Carriage Meadows South at Lorson Ranch Filing 2

PUD Development Plan, Preliminary Plan, Early Grading & Wet Utilities

A PLANNED UNIT DEVELOPMENT FOR CARRIAGE MEADOWS SOUTH AT LORSON RANCH FILING 2

SITE PLAN
P4 OF

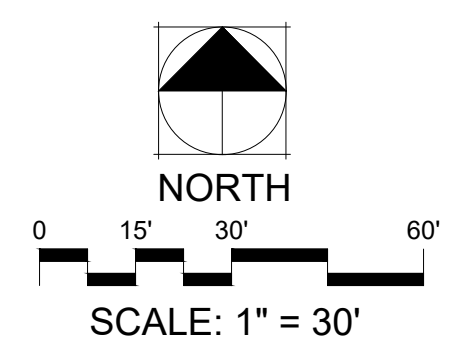
Internal trail
connections to the
larger trails in the
development should
be clearly identified,
tot lots/ play areas?

Call out the floodplain.

Provide a legend
or label all of the
lines.
